MILITARY SPECIFICATION

CIRCUIT BREAKERS (AUTOMATIC - ALB-1) AND SWITCH, TOGGLE (CIRCUIT BREAKER, NON-AUTOMATIC - NLB-1) AIR, INSULATED HOUSING, 125 VOLTS AND BELOW, A.C. AND D.C., (NAVAL SHIPBOARD USE)

This amendment forms a part of MIL-C-17588E(SH), dated 26 November 1985, and is approved for use by the Naval Sea Systems Command, Department of the Navy, and is available for use by all Departments and Agencies of the Department of Defense.

1B. Outline dimensions for mounting bases for one circuit breakers.

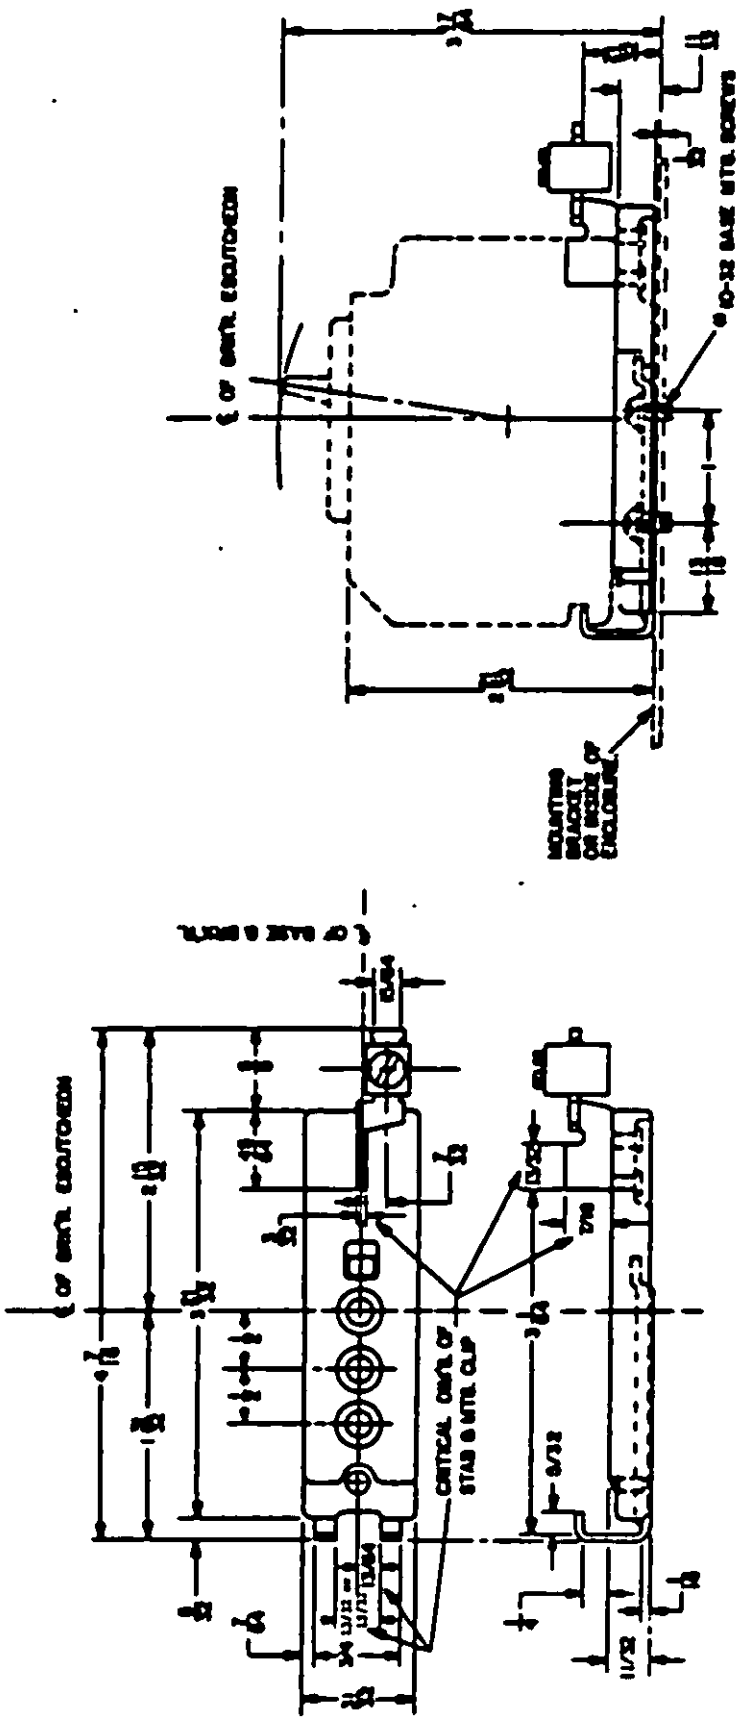
* Figure 1: Delete and substitute attached figure.

1D. Outline dimensions for mounting bases for circuit breakers.

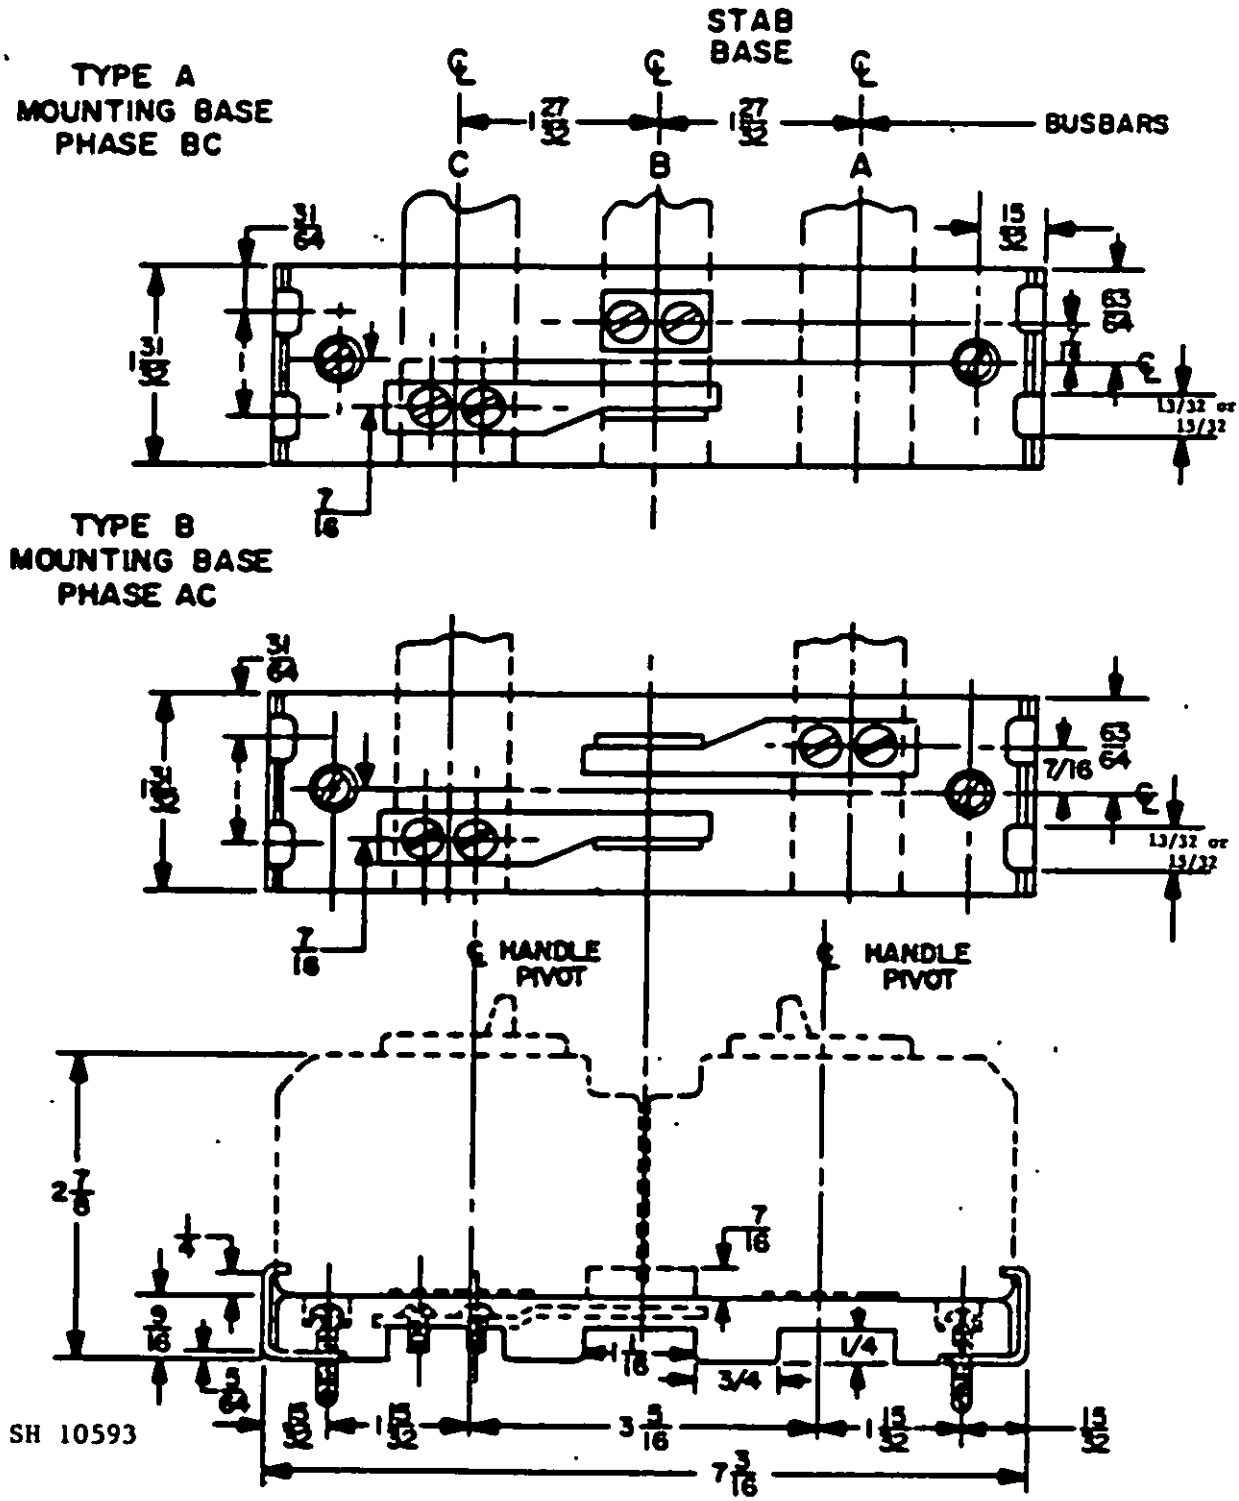
* Figure 1: Delete and substitute attached figure.
